## **Legislative Council Public Works Subcommittee**

## PWP Item No. 716CL Tseung Kwan O further development – infrastructure works for Tseung Kwan O Stage 1 landfill site

## Follow-up to meeting on 27 November 2019

PWP ITEM NO. 716 CL - TSEUNG KWAN O FURTHER DEVELOPMENT - TSEUNG KWAN O STAGE 1 LANDFILL SITE FIGURE 1 - CYCLE TRACK LOOP AT TSEUNG KWAN O SOUTH

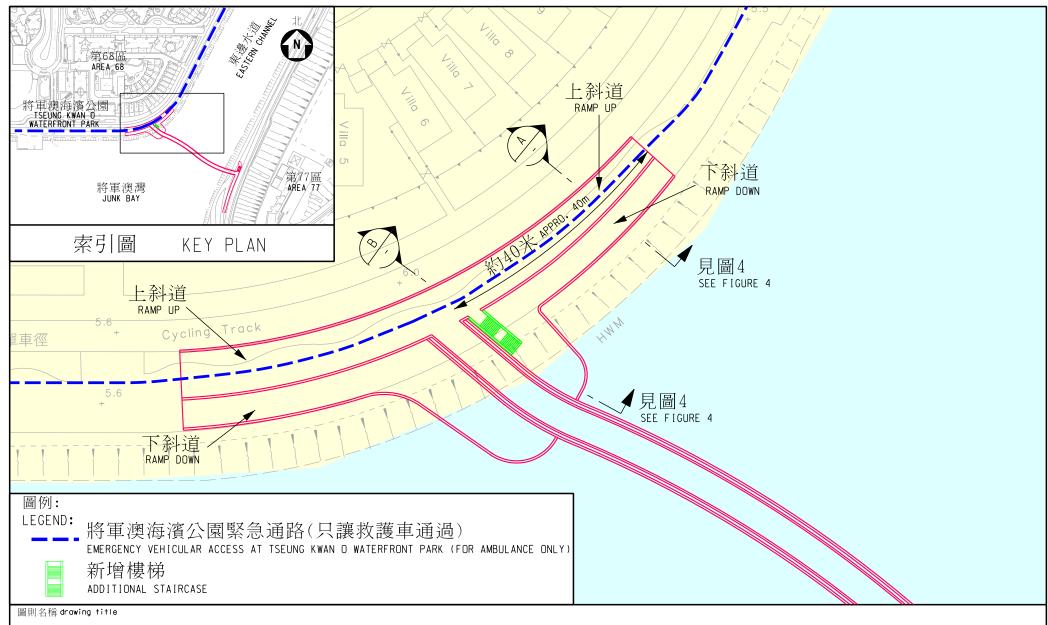
- (a) At the request of the Chairperson, Hon WU Chi-wai, Dr Hon KWOK Ka-ki and Hon Alvin YEUNG, the Government shall provide supplementary information on:
  - (i) the considerations in deciding whether to provide cycle tracks or designated cycle lanes on the proposed Southern Bridge, and
  - (ii) the details and progress of the current pilot project of implementing shared-use paths for pedestrians and cyclists.

According to the current development plan of TKO South, the Government will provide a 5 kilometres (km) long cycle track loop via the promenade of TKO Area 68 and TKO Town Centre South, the existing Northern Bridge across the Eastern Channel, the promenade of TKO Area 77 and Area 86, and the Cross Bay Link under construction, facilitating the public to cycle within the areas for commuting and leisure purposes. The planned layout

of the cycle track loop at TKO South can be referred to Figure 1.

On item (i) above, regarding the provision of cycle tracks or designated cycle lanes on the proposed Southern Bridge, the main design considerations adopted by the Government include the holistic plan of cycle tracks in TKO district, the function and cost effectiveness of the proposed Southern Bridge, and the local views, as briefly set out below:

To conclude, from the perspectives of the planning, function and cost effectiveness of the proposed Southern Bridge and local views, provision of cycle track on the proposed Southern Bridge is not necessary.

PWP ITEM NO. 716CL - TSEUNG KWAN O FURTHER DEVELOPMENT - TSEUNG KWAN O STAGE 1 LANDFILL SITE FIGURE 3 - GENERAL LAYOUT PLAN OF WESTERN RAMPS

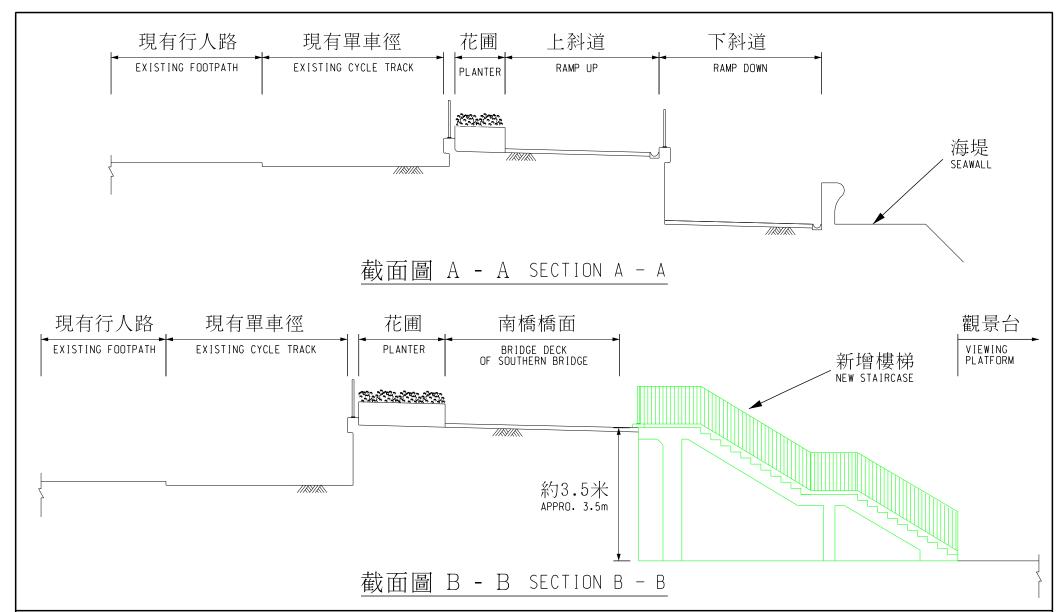
(ii) Review the possibility of adding stairs to the ramp connecting the proposed Southern Bridge to TKO Area 68

At the western end of the proposed Southern Bridge connecting to TKO Area 68, the left and the right sides of the bridge deck are each connecting to the existing TKO Waterfront Park via a 40m long up-ramp and the viewing platform under the bridge deck via a 40m long down-ramp (Figure 2). According to the design, functionally, the up-ramps on both sides at the western end will form part of the emergency access of the TKO Waterfront Park for the passage of ambulance when needed. Therefore, adding staircases to the up-ramps is not suitable. Upon reviewing the connection between the bridge deck and the viewing platform underneath, the CEDD propose to link them up with an additional staircase, so as to provide people with a convenient access (Figures 3 & 4).
